Section 278 Works, Long Lane / Woodmansey Mile, Beverley

Stage 3 Road Safety Audit

STAGE 3 ROAD SAFETY AUDIT

Ref: 23-381.001.01

Title: STAGE 3 RSA PROBLEM LOCATION PLAN

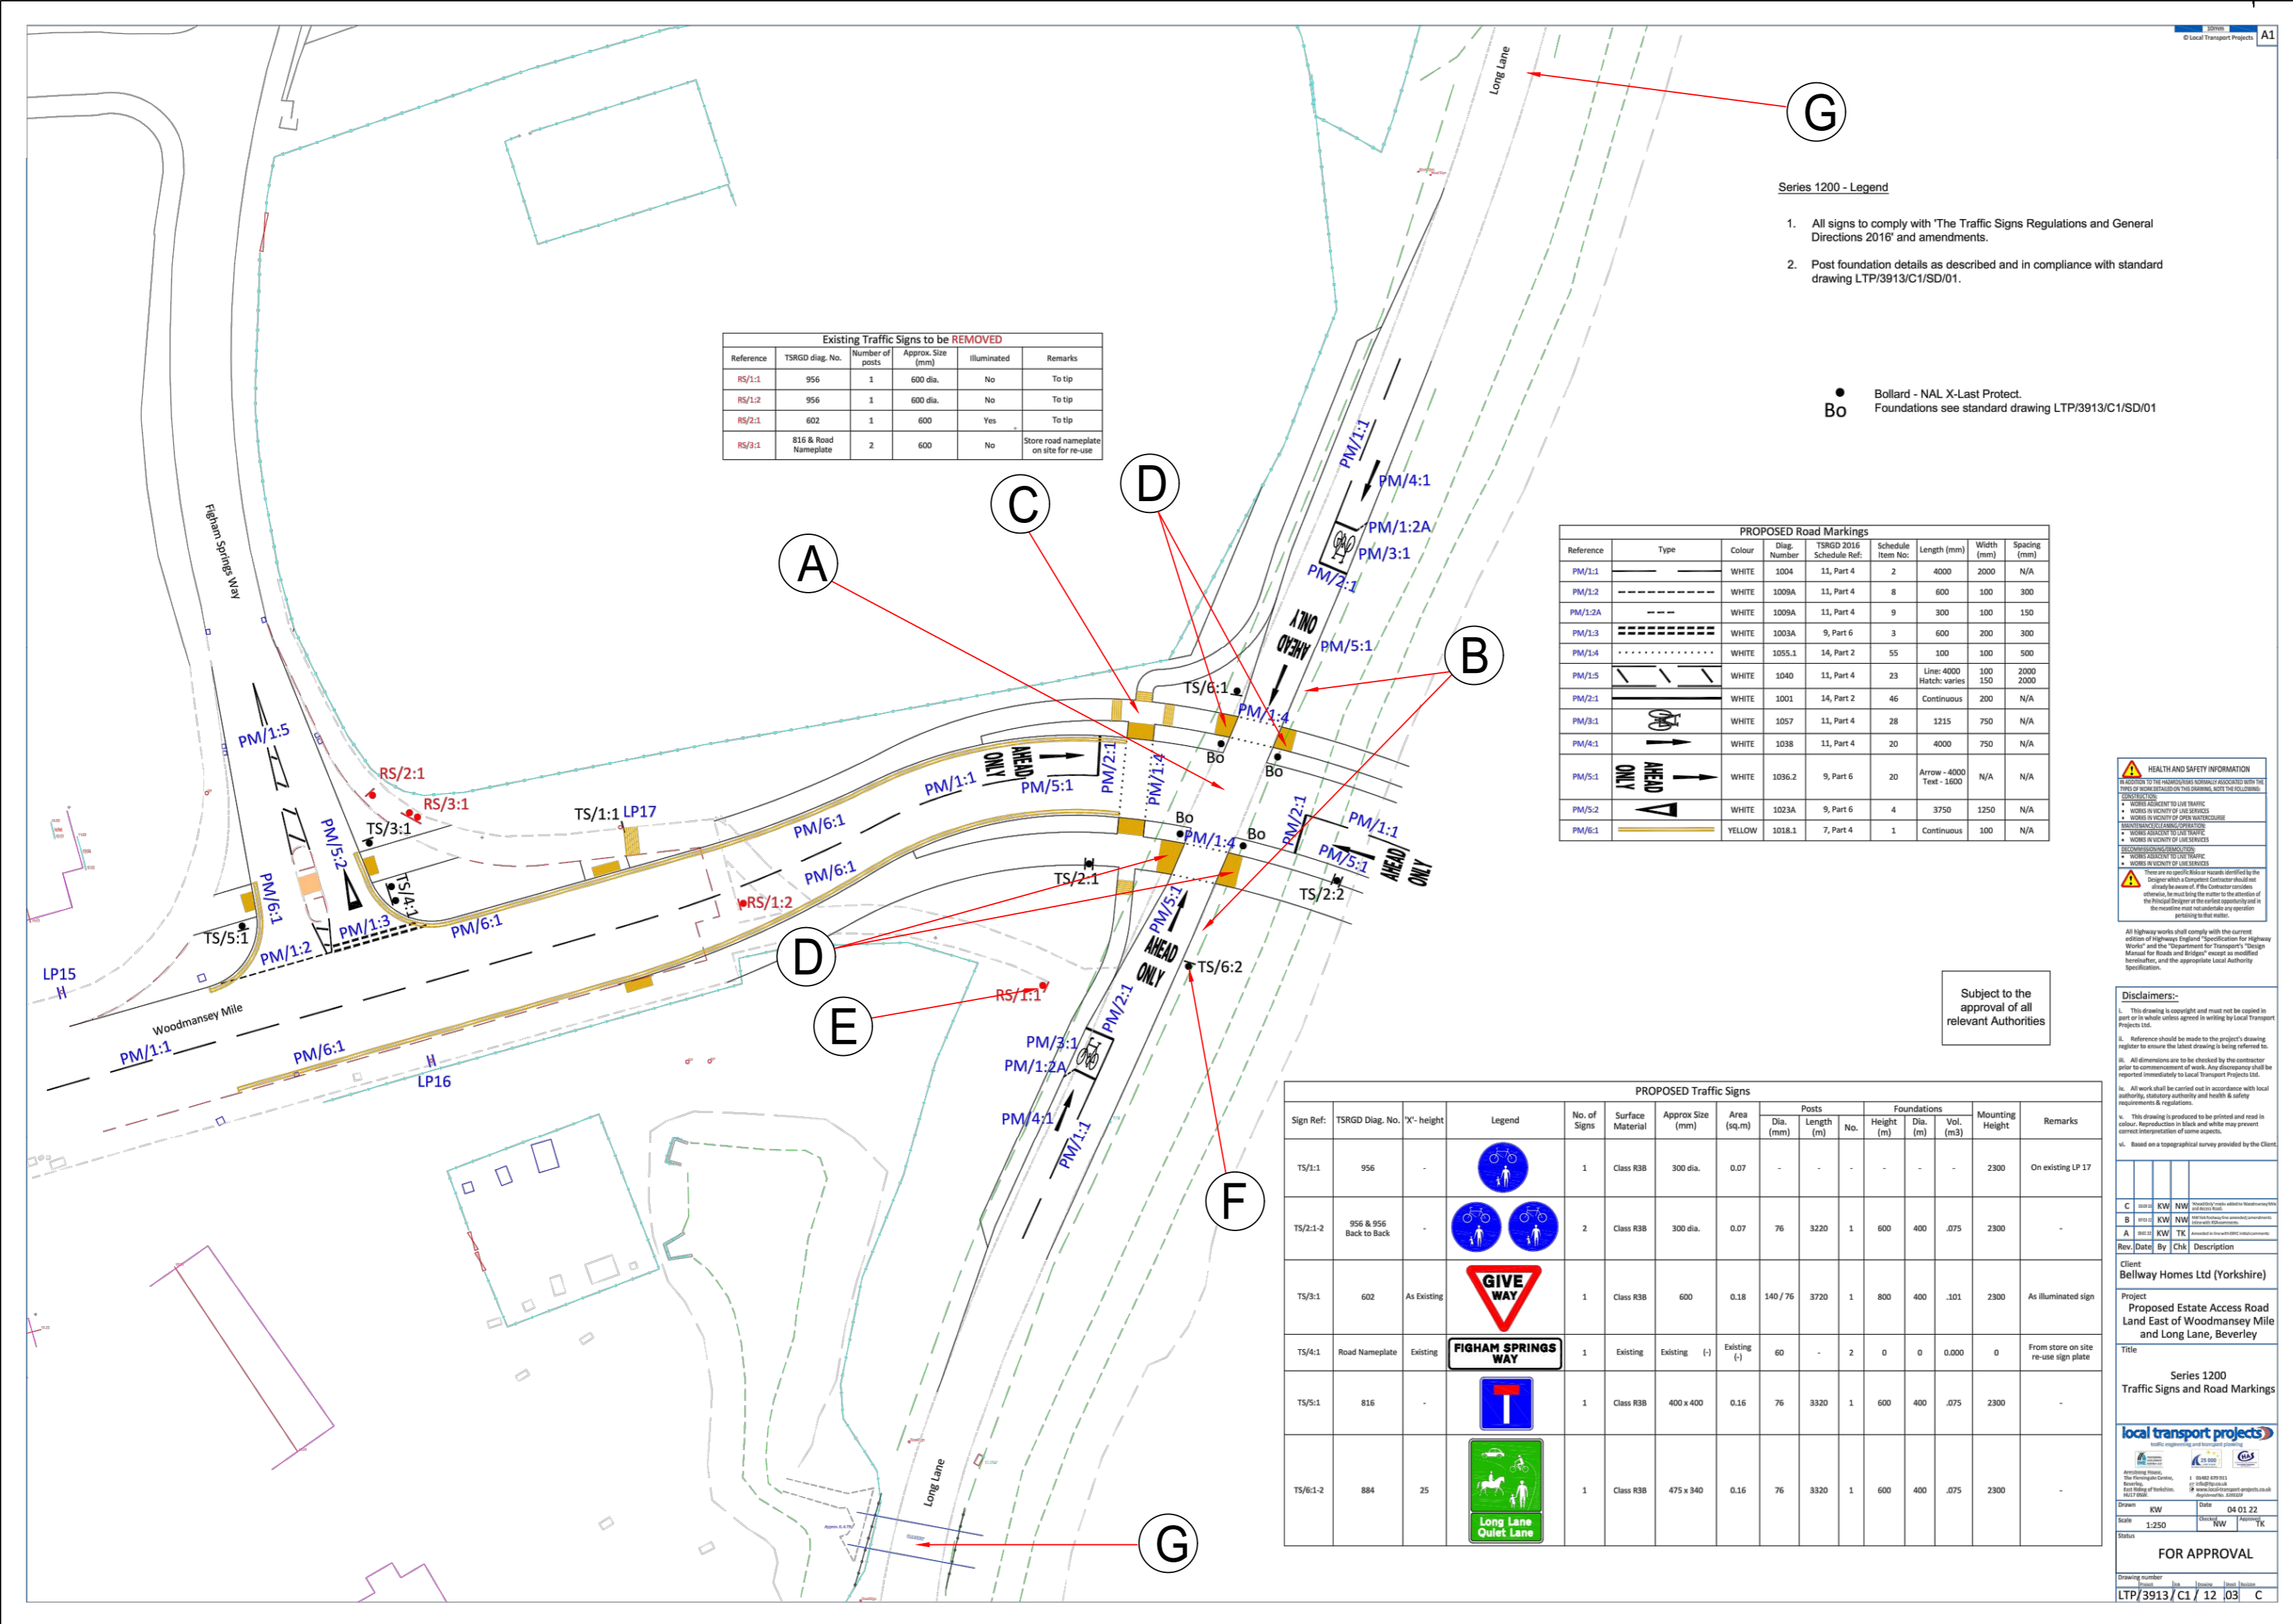
- 3.1 All items raised within this Stage 3 RSA are shown on the annotated plan at **Appendix BGH1**.

It was noted during the site visit that fencing does not extend fully along the carriageway boundary to both the north and south of the culvert across the water course which runs parallel to Long Lane. There is also a lack of fencing on the top of the headwalls to both sides of the culvert. This allows pedestrian access from the highway to the embankment and area surrounding the water course and therefore increases the risk of falls and water related injuries.

It was noted during the site visit that corduroy paving has only been installed across part of the footway to the northwest of the signalised junction, to the east and west of the tactile paving associated with the uncontrolled pedestrian crossing location on Woodmansey Mile. There is also corduroy paving across the footway connection to the rear of the footway, in line with the uncontrolled crossing, which provides a footpath connection heading north from the junction. There are no shared footway cycleway signs in the vicinity of the paving arrangements indicating what is shared footway cycleway and what is footway, which may result in pedestrians and cyclists being unsure as to what the status of the footway is.

Tactile paving has been installed incorrectly at a depth of less than 1.2 metres to either side of the uncontrolled pedestrian crossings across the northern and southern arms of the signalised junction on Long Lane and may cause confusion leading to collisions involving visually impaired pedestrians.

Signs to diagram 956 of the Traffic Signs Regulations and General Directions remain in place in the verge to the west of Long Lane on the southern arm of the junction. These signs incorrectly indicate that the footway is a shared footway cycleway and will lead to an increased risk of collisions between pedestrians and cyclists.

The Quiet Lane sign located in the eastern verge on Long Lane, to the southeast of the signalised junction, partially obstructs visibility to the secondary signal head associated with northbound traffic. The obstructed visibility of the signal head increases the risk of drivers travelling northbound entering the junction into the path of vehicles or cyclists travelling eastbound or westbound on Woodmansey Mile, leading to an increased risk of collisions.

No advance warning signs have been provided on the northbound and southbound Long Lane approaches to the signalised junction. The risk is that drivers approaching the junction are unaware of the presence of signals at the junction on their approach and this may result in sudden braking leading to shunt type collisions of loss of control type collisions on the approaches to the junction.

It is recommended that fencing is extended along the boundary of Long Lane and the area surrounding the headwalls to control pedestrian access.

It is recommended that corduroy paving is extended to the edge of the footway and clear signage is provided to differentiate between shared footway cycleway and footway. Signage should also be provided to define the use of the northern footway to the east of the signalised junction on Woodmansey Mile. It is recommended that guidance contained within LTN 1/20 is considered as part of any further changes to the tactile paving and signage design.

It is recommended that the tactile paving arrangements are extended to ensure that the tactile paving arrangements are consistent with current guidance.

It is recommended that the signs are removed.

It is recommended that the Quiet Lane sign is relocated away from the line of sight for drivers travelling northbound on Long Lane.

It is recommended that traffic signal advance warning signs are installed on the approaches to the junction on Long Lane.
